879-Full: Active Rift Development

- L. McNeill, I. Bailey, R. Bell, J. Bull, et al.

Summary- Concerns

COR-03

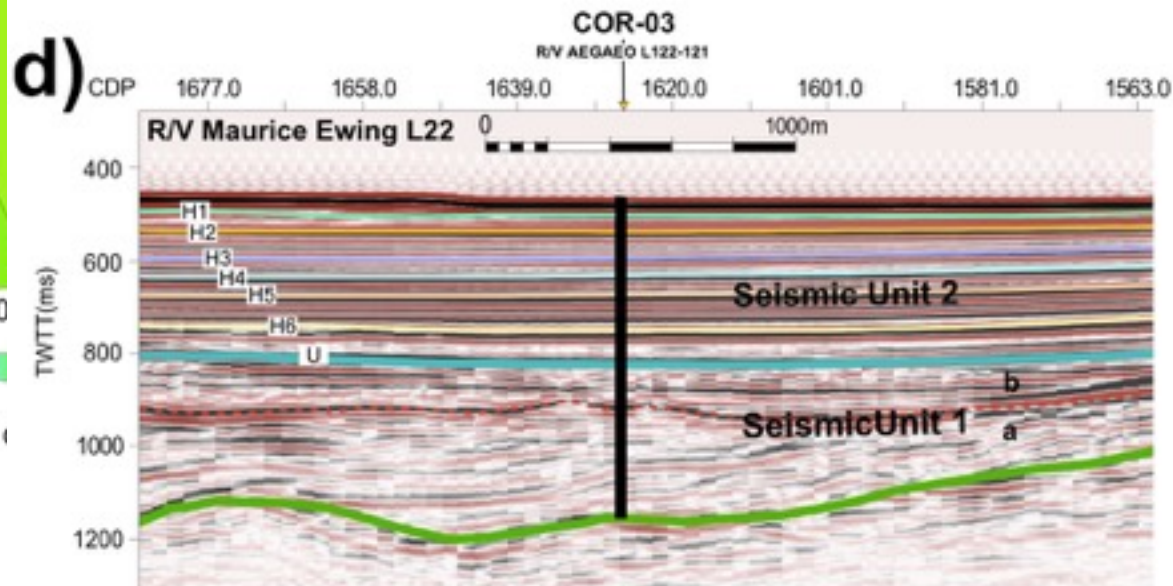
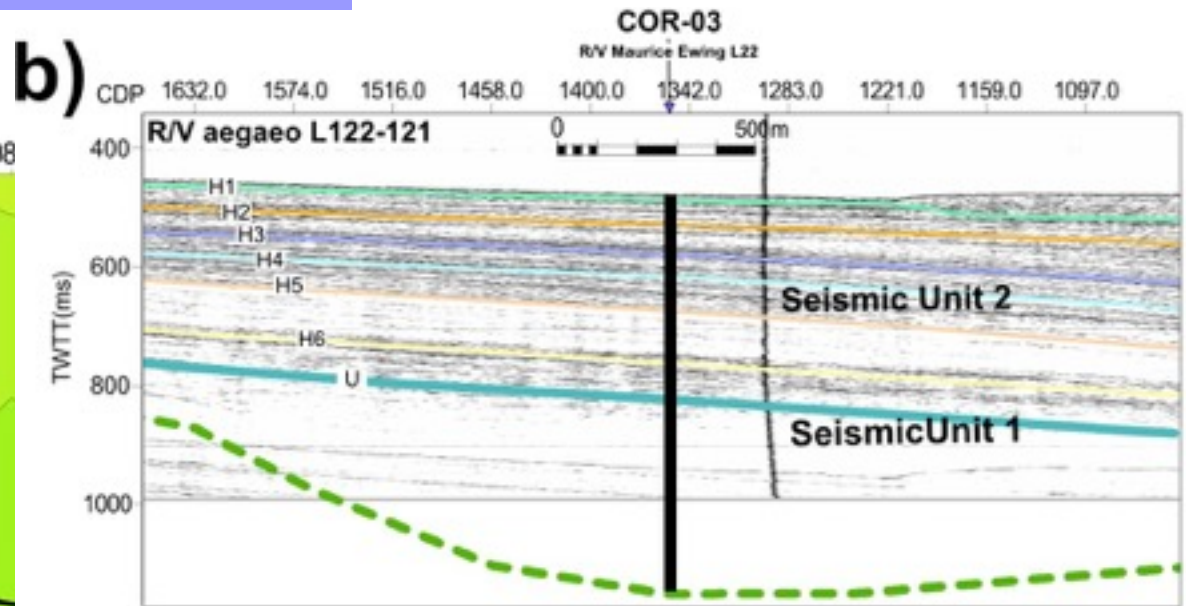
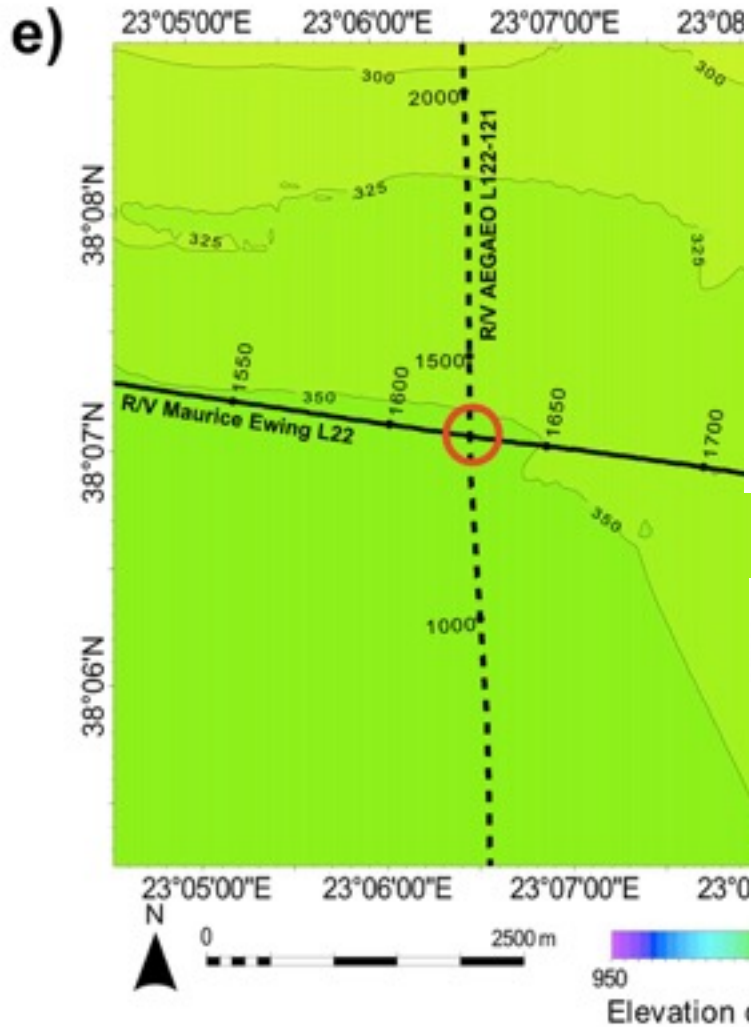
- *Concern: COR-03, COR-04 target not resolved on crossing lines.*
- *Addressed by response letter; targets are resolved on adjacent lines; may still be concern to EPSP?*
- Hole COR-03 penetrates high amplitude mound within SU1, which is not imaged on the crossing line due to attenuation.
- *Addressed by response letter; Proponents claim no evidence of gas based on amplitudes. EPSP issue.*
